# Access Compliance Report

## Public Rights-of-Way

### (Pedestrian Signals)

Intersection ID: N/A	Main Street:	Cross Street: N/A	Location: N/A
ADA ID: CB0BF3F945CA	Signal Type: One Push Button-Non APS	Overall Compliance: No	Severity Score: BTN 1: N/A BTN 2: N/A No BTN: N/A
Codes/Mitigation Info/Possible Solution		Field Measurements/Component Compliance

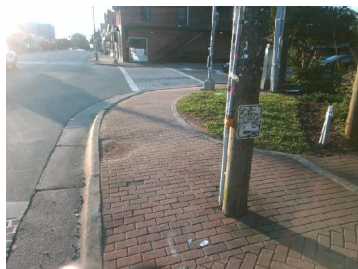
Surveyor Notes: B1 SIGN COVERED IN  
GRAFITTI

PROW/ADA: R209.1, TMUTCD 4e.08, R404.2,  
R404.3

Possible Solutions: Remove & Replace Sign.  
Remove and Replace Clear Space.
